Comments on Phase 2 of the Cibola National Forest "Potential Wilderness Inventory and Evaluation Process"

Bear Mountains, Magdalena Ranger District

September 23, 2015

Arian Pregenzer 13013 Arroyo de Vista NE Albuquerque, NM 87111 (505) 217-9150

Figure 2. Phase 2 Inventory Results

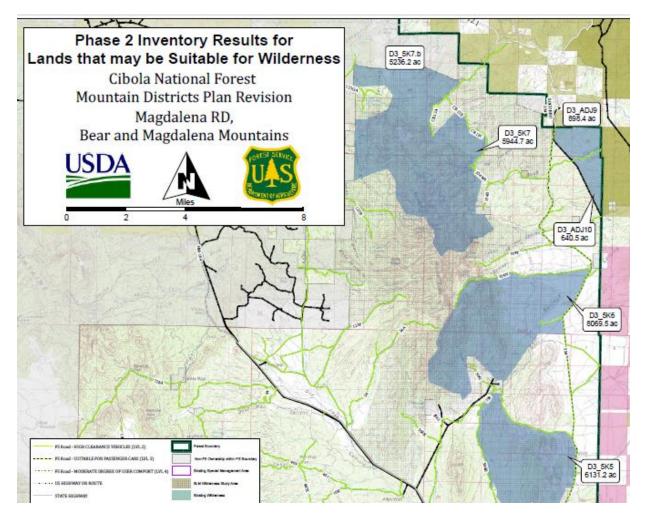
The Forest Service has now provided a revised map "<u>Phase 2 Inventory Results for Lands that may be</u> <u>Suitable for Wilderness</u>," as shown below. Regarding the Bears, it is very encouraging to see that nearly 26,300 acres are identified as potential wilderness in polygons D3_5K7, D3_5K6, D3_5K5, D3_ADJ9, and D3_ADJ10. These are the areas shown in blue on the map.

However, important areas now have been excluded in D3_5K7 and D3_5K6. Moreover, the two key areas mentioned above continue to be left out: 1) the NE corner west 354 and the area east of 354 but west of the powerline and north of 354O.

Figure 3. Map of Substantially Noticeable Features

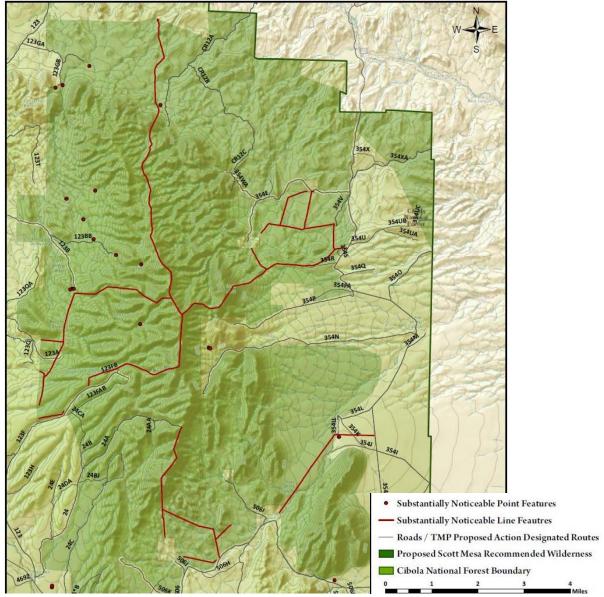
The Forest Service also provided digital data on the locations of the SNFs, which is shown on the map below, although the features were un-named and thus difficult to link to the text in their written explanations above.

Based on the results of my fieldwork, I respectfully disagree with most of the Forest Service's assertions that fences and other features constitute "substantially noticeable features" sufficient to disqualify these lands as wilderness according the Forest Service's criteria. I also found numerous instances in which the locations of SNFs as provided by the Forest Service are significantly inaccurate. The data presented in the next section will demonstrate that:

- The vast majority of fences in the Bear Mountains and environs are wood post rather than steel.
- Vegetation and rugged topography through most of the area is sufficient to screen fences and other human developments from view from most vantage points.
- Most stock tanks and other developments are located on roads that were cherry-stemmed in the Phase 1 Inventory, and therefore do not contribute to the deletion of land during Phase 2.
- The data provided by the Forest Service regarding the locations of "substantially noticeable" fences and other developments are often inaccurate by up to 0.75 mile.

These discrepancies lead me to conclude that the Forest Service did not perform an on-the-ground assessment of all of these features, which begs the question of how this information was obtained. Not only do these inaccuracies impede independent evaluation, they also cast doubt on the credibility of other information provided to the public by the Forest Service.

With the exception of land in the southwest corner of Polygon D3_5K6, I conclude that fences and other developments disqualify no land in D3_5K6 and D3_5K7 from wilderness consideration.

Moreover, there are no features disqualifying land in the NE corner west of 354 and this should be added to Polygon D3_5K7.

Figure 4. Proposed Bear Mountain Wilderness for the Area North of 506.

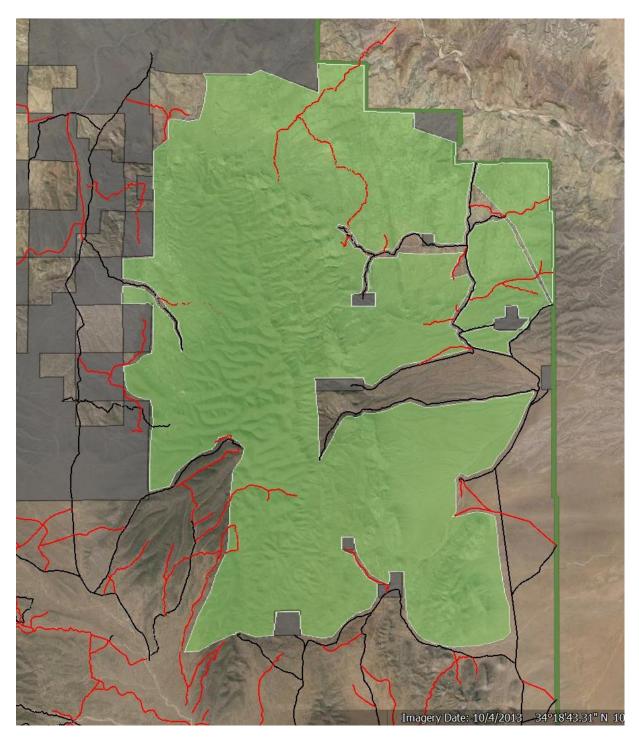
In addition, I strongly recommend including a significant area east of 354 and west of the powerline in the next phase of evaluation. Despite its falling below 5,000 acres, it meets other requirements for wilderness and its proximity to other wilderness would ease any management concerns.

A map showing the area north of 506 that I propose taking into the Phase 3 Analysis is presented on the next page.

Figure 21. Stock tanks as seen using Google Earth. The red X's above are the locations identified by FS. No evidence of solar panel or windmill from Google Earth. GPS coordinates: $34^{\circ}17'06.65''N$, $107^{\circ}17'03.72W$. Imagery date: 10/4/13. About 250 feet above ground.

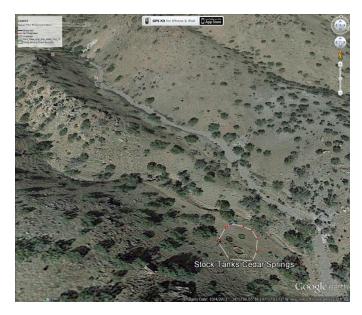
These developments would not compromise the proposed wilderness, as they lie outside its boundary as originally proposed by Forest Service. However, I could see nothing looking down at this canyon from the rim of the canyon above. Using Google Earth, I found three features about 10 feet diameter that look like drinkers. However, I could see no evidence of a solar panel or windmill.

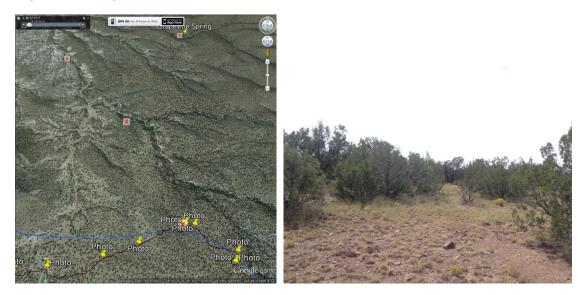
I could find no drinkers at the locations provided by the FS downstream of Lumber House Spring 2 (either in person or using Google Earth). I located one drinker / corral just south of the intersection of 123BB with 123B while I was hiking, and three others along 123B using Google Earth. These are in a line roughly parallel with the locations provided by the Forest Service, but about 0.75 mile west along 123B. None of these features should preclude wilderness designation, as they are on a road that could be cherry-stemmed to provide access to ranchers. In fact, were their locations shown accurately, they would not have been included in the Phase 1 inventory map, which cherry-stemmed 123B and 123BB.
